REVIEW OF
RESISTANCE TEMPERATURE DETECTOR
TIME RESPONSE CHARACTERISTICS

SAFETY EVALUATION BY
U.S. NUCLEAR REGULATORY COMMISSION
OFFICE OF NUCLEAR REACTOR REGULATION
DIVISION OF SYSTEMS INTEGRATION
INSTRUMENTATION AND CONTROL SYSTEMS BRANCH

NOVEMBER 1980

Figure 2.1 Plot of correction factor $[f(\tau_2/\tau_1)]$ vs pole ratio $[\tau_2/\tau_1]$.

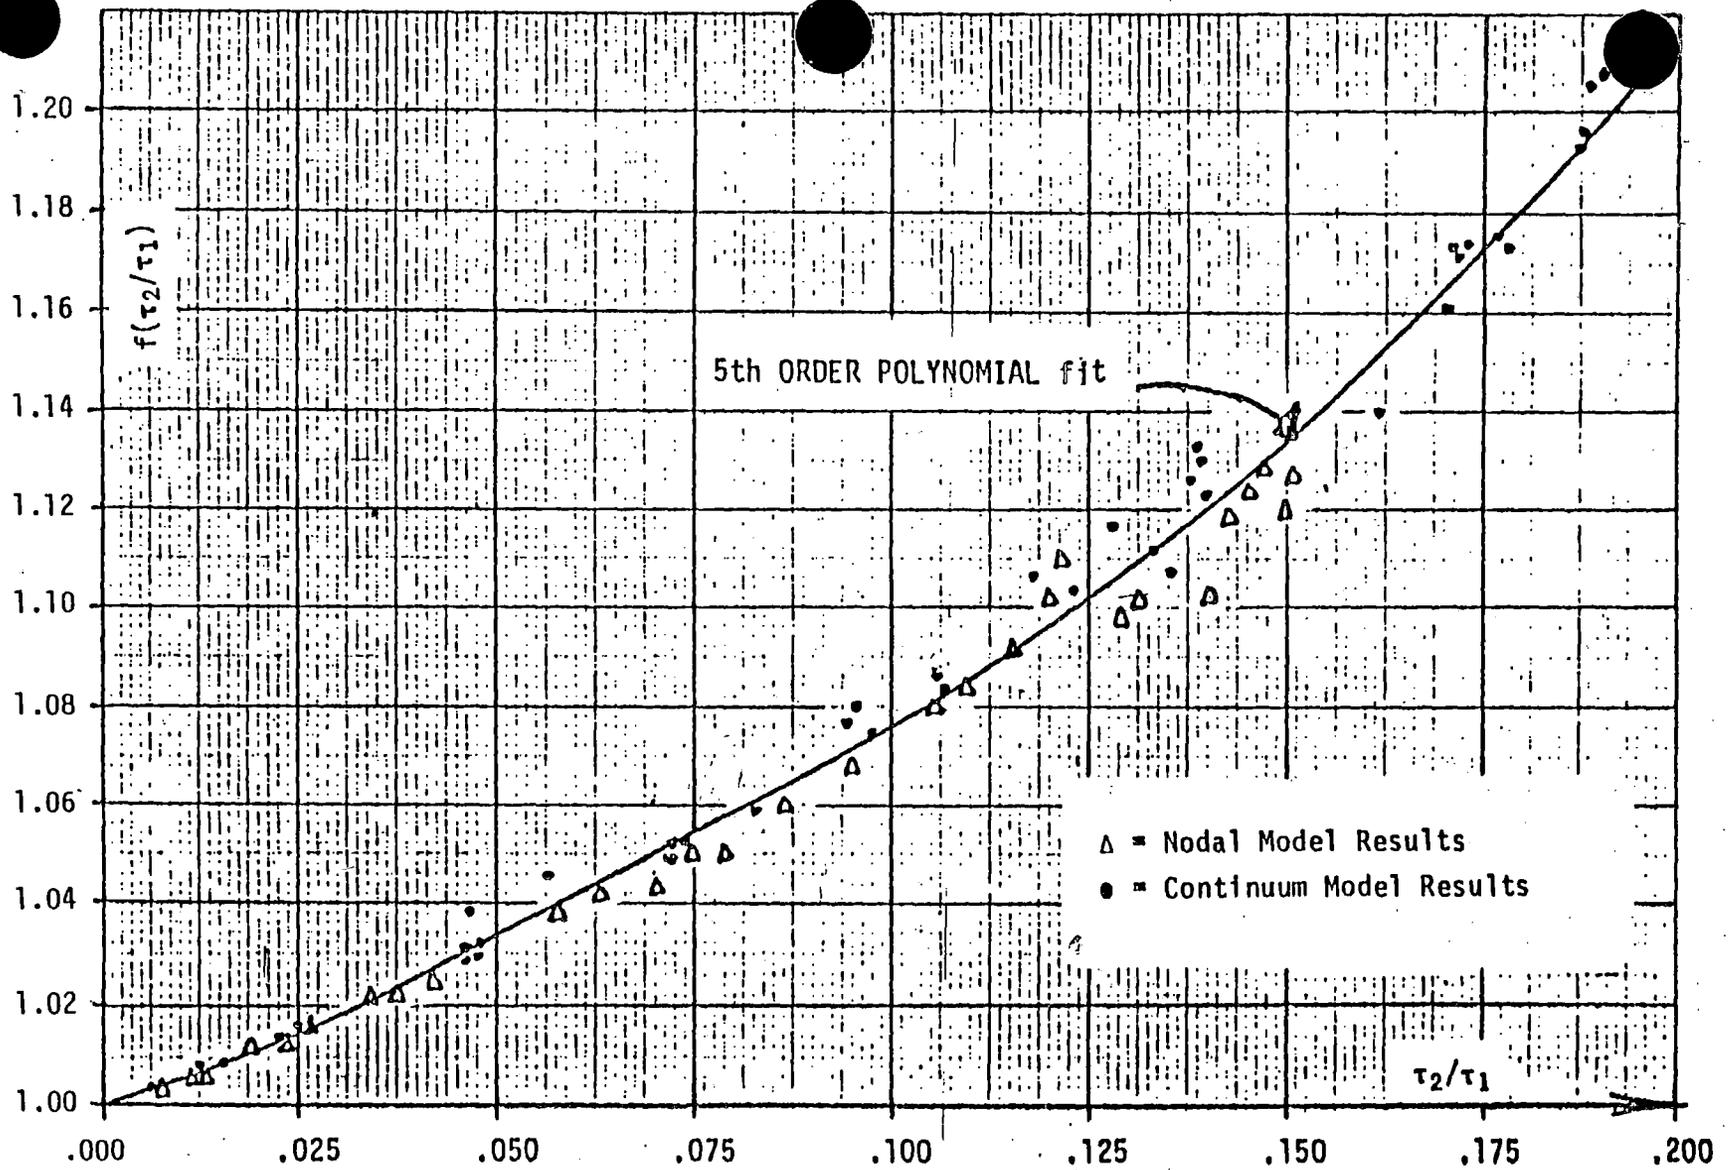
where $f(\tau_2/\tau_1)$ is given by the empirical relationship of figure 2.1. Figure 2.1 was constructed by mathematically computing the Plunge τ (equation 2.2) and $\tau_1 [1 - \ln(1 - \tau_2/\tau_1)]$ for a number of different hypothetical RTDs and plotting the ratio of the two. The hypothetical RTDs had a variety of sizes and geometries, which included both hollow core and central element RTDs. Thus the curve of figure 2.1 applies to any RTD which fulfills the two requirements of section 2.2.2. The fact that this large variety of RTDs all enjoy the same $f(\tau_2/\tau_1)$ is, on the surface, rather amazing. With such a good correlation, one would naturally be inclined to search for an underlying physical reason for all RTDs to display the same $f(\tau_2/\tau_1)$. However, to date this underlying physical relationship has eluded us.

Figure 3.1 Empirical Correlation Curve for Plunge τ versus LCSR τ
for Rosemont RTD Model 104AFC. (Combustion Engineering RTD)

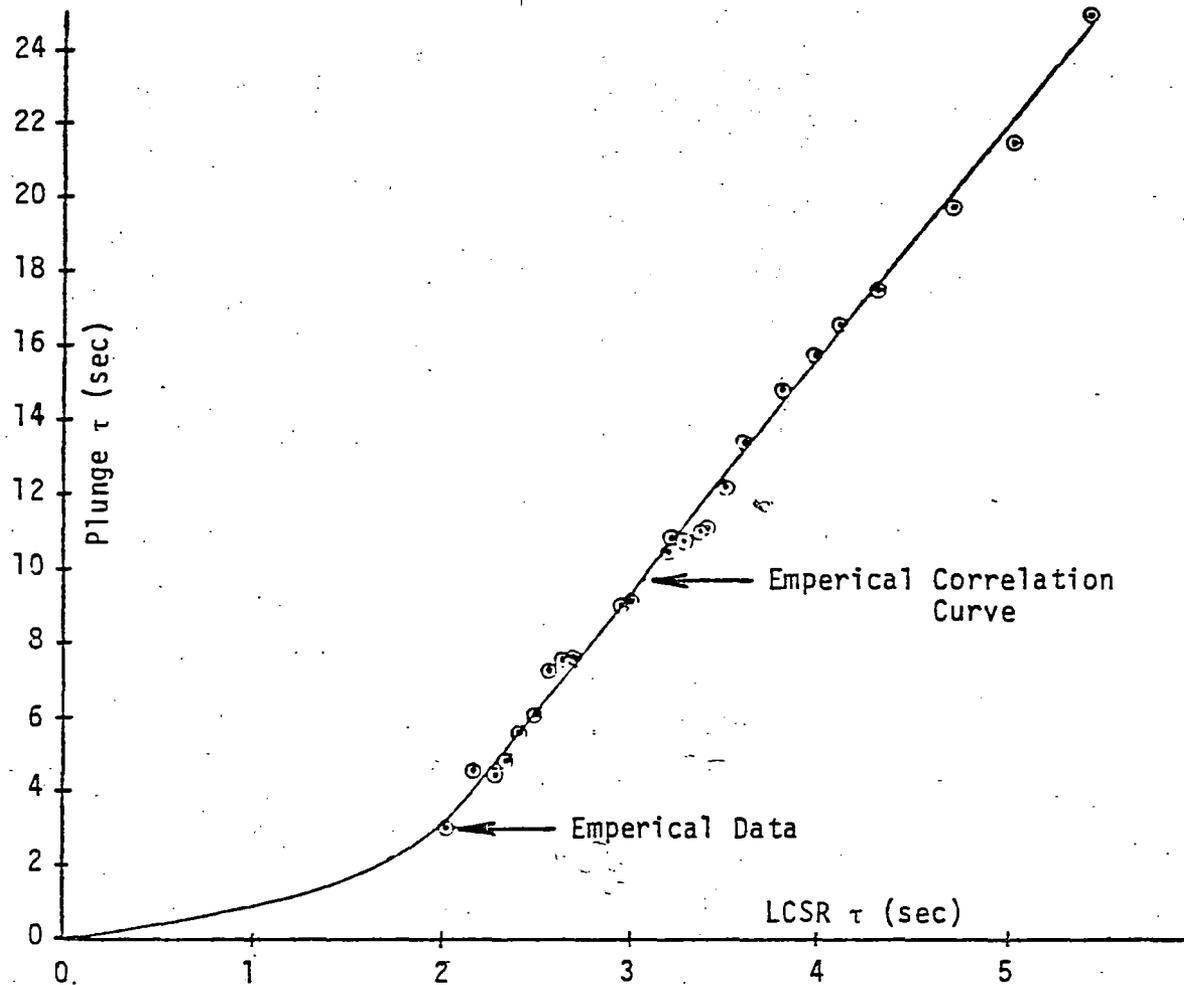
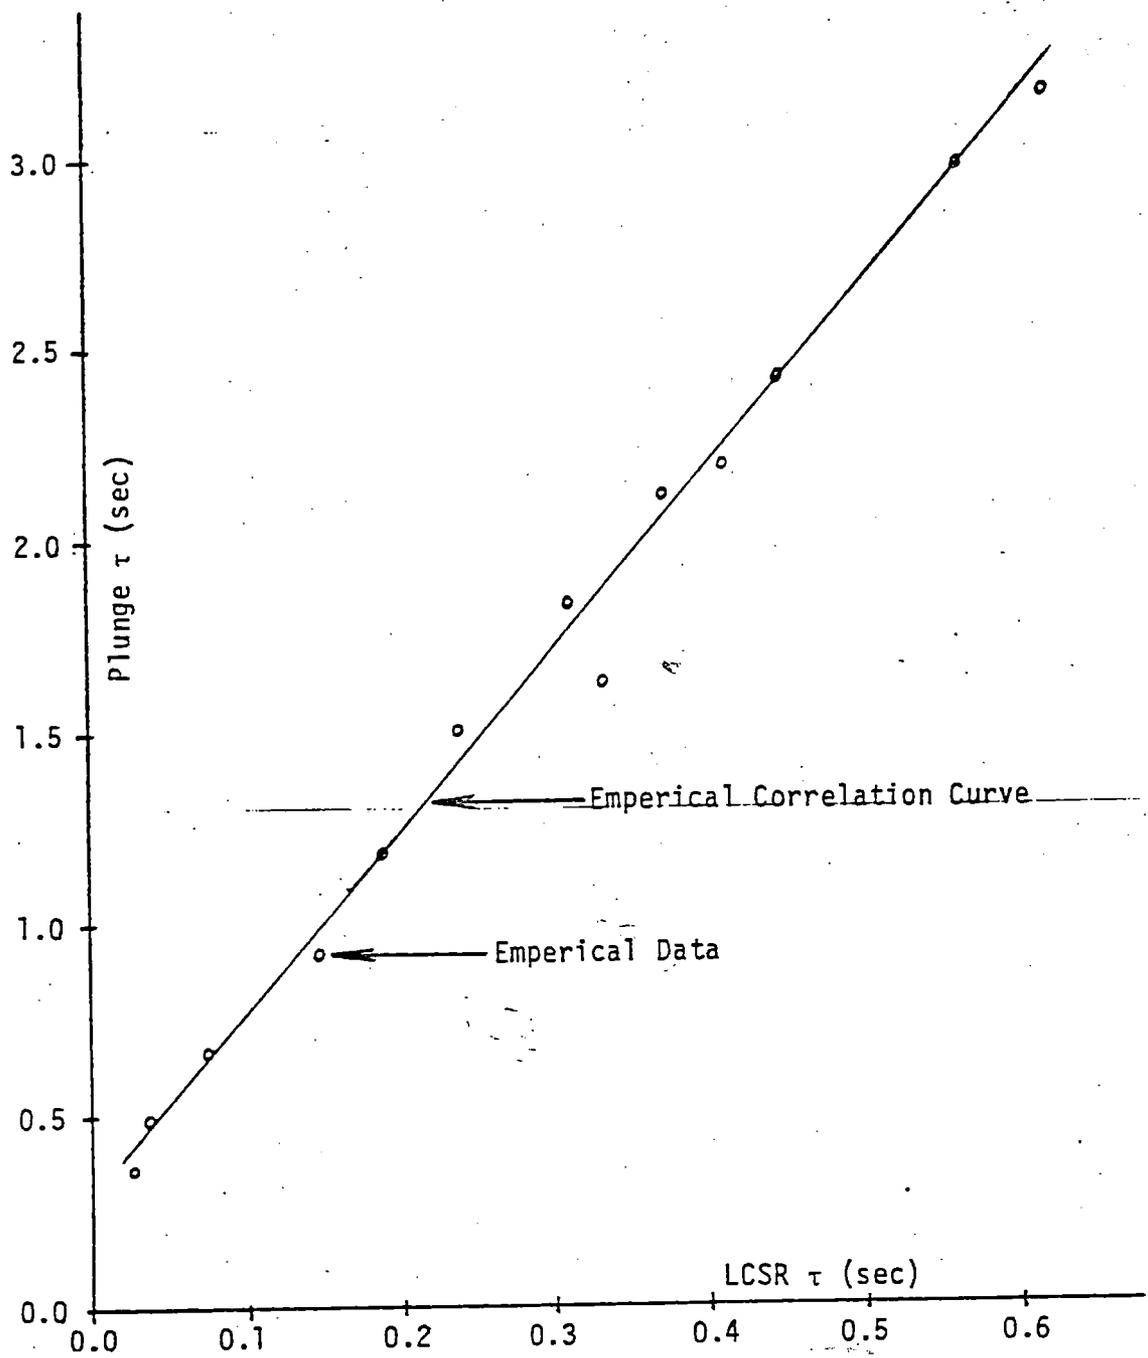
The U of T investigators attempted to correlate the Plunge τ with the LCSR τ . In making this correlation the time response of the RTD was varied by adding tape or rubber insulation around the RTD and measuring both the Plunge τ and the LCSR τ . Two such correlations are shown in figures 3.1 and 3.2.

An obvious difficulty with this method is the following: This correlation was formed by altering the thermal resistance on the surface of the RTD. When an RTD degrades, it is most likely due to increases in the thermal resistance of the RTD internals or the RTD-thermowell gap. Therefore one would expect to find a different correlation for normal degradation than that determined by adding insulation to the surface of the RTD. For this reason we do not, at present, consider the correlations of figures 3.1 and 3.2 to be sufficiently well substantiated to be used in the determination of the Plunge τ .

While not providing an accurate means of computing the Plunge τ , these correlations are useful for the degradation test. If in a degradation test the LCSR τ is found to increase, then from the correlation the approximate increase in the Plunge τ can be determined. If the Plunge τ determined in this way is near the value assumed in the safety analysis, this would indicate that it is necessary to measure the Plunge τ via the usual LCSR procedure.

Figure 3.3 Empirical Correlation Curve for Plunge τ versus SHI for Rosemont RTD Model 104AFC. (Combustion Engineering RTD)

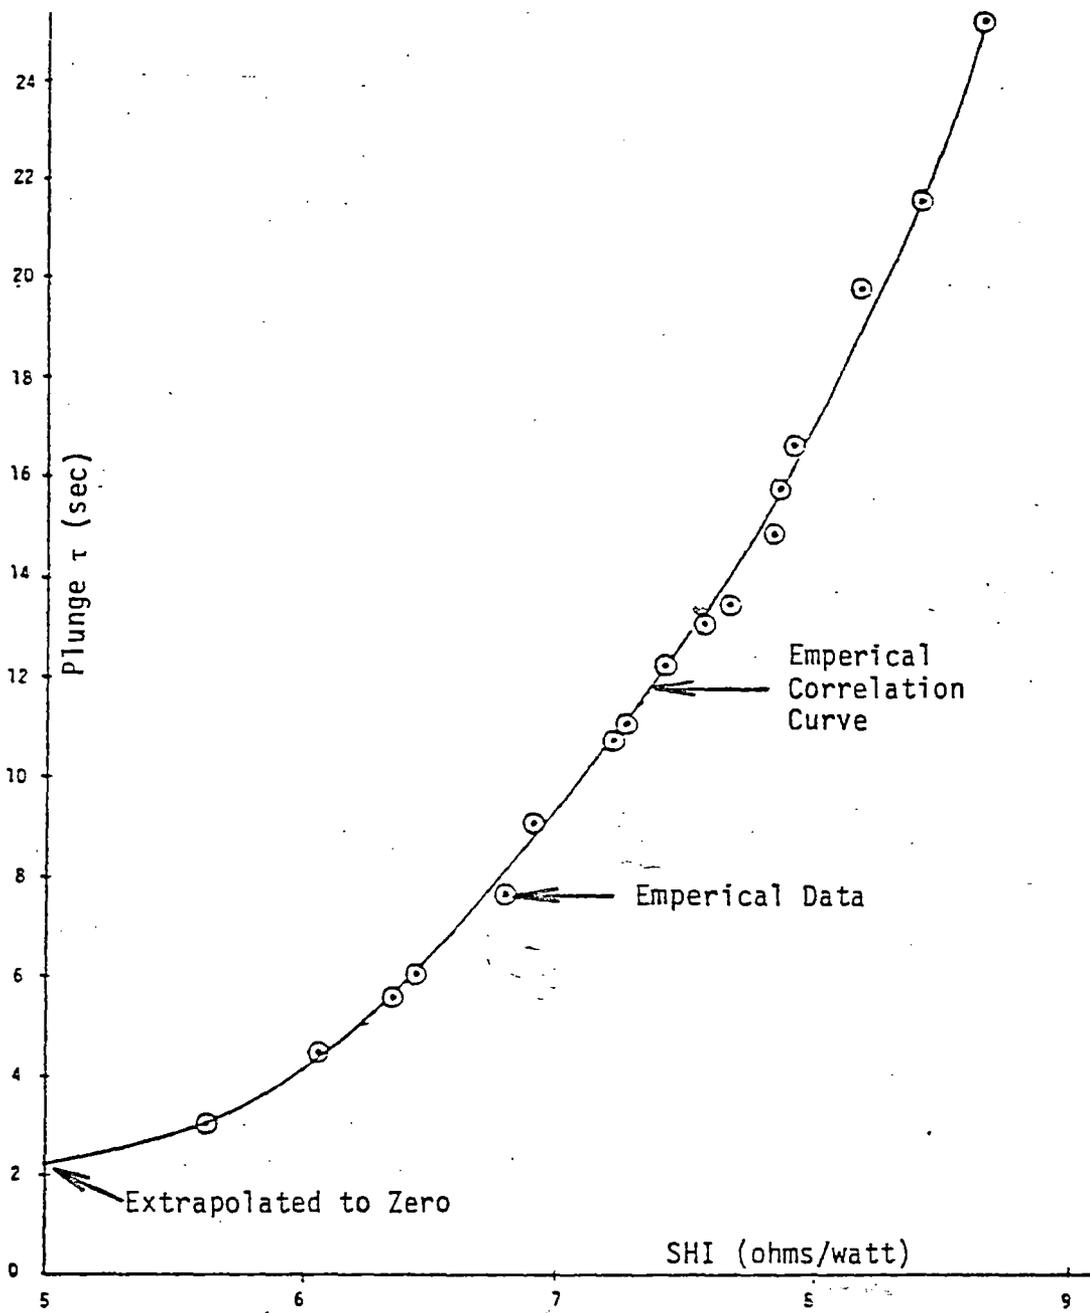
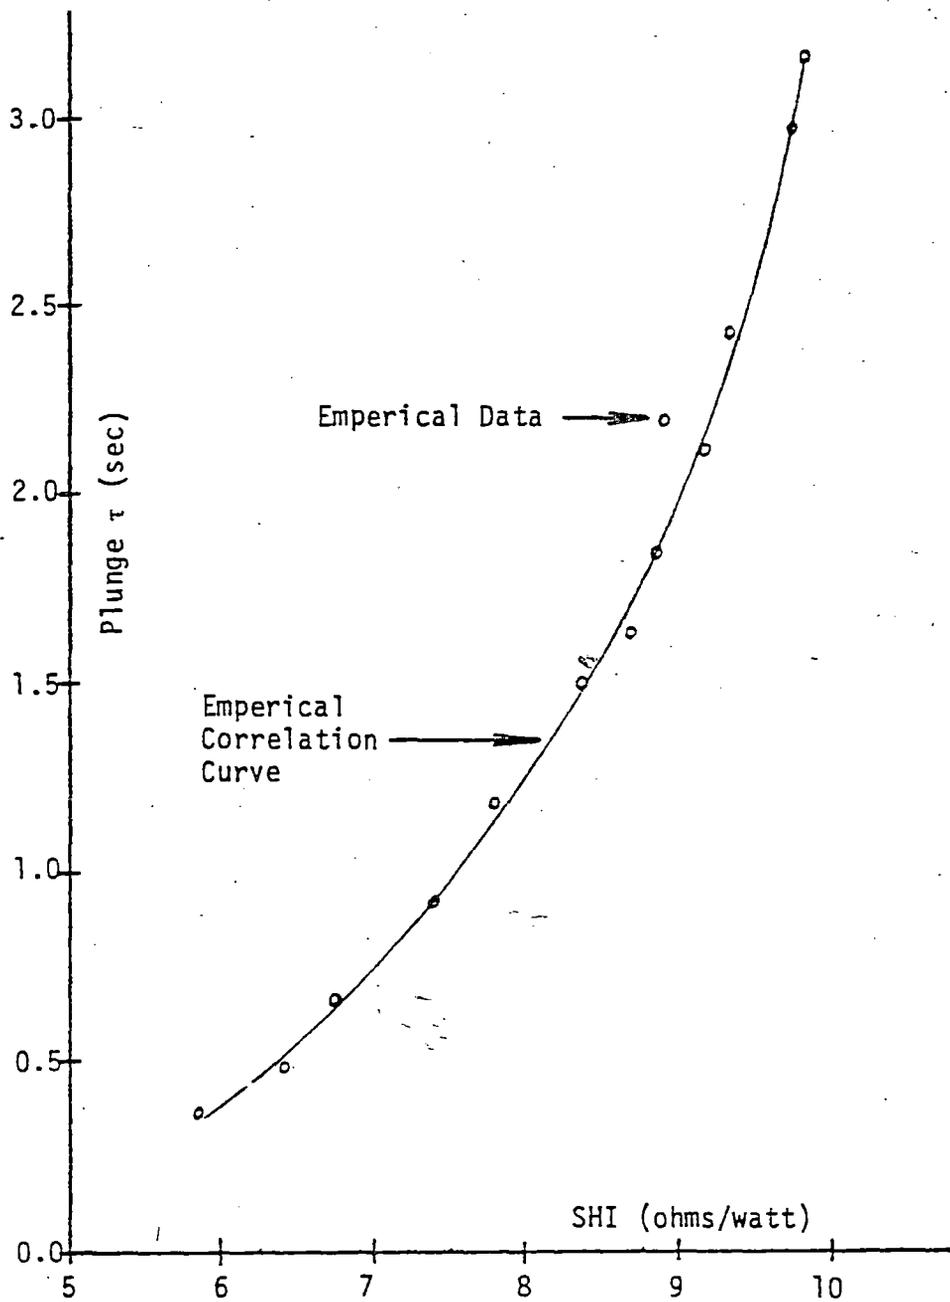
Again, as with the LCSR τ measurement, the RTD time response was varied by adding insulation to the surface of the RTD, and plots of Plunge τ versus SHI were constructed. Two such plots are shown in figures 3.3 and 3.4.

These correlations suffer the same problem as the Plunge τ versus the LCSR τ correlations, and thus we do not, at present, accept them as viable means for computing the Plunge τ . However, like the Plunge τ versus LCSR τ correlation, the Plunge τ versus SHI correlations would be useful in a degradation test.
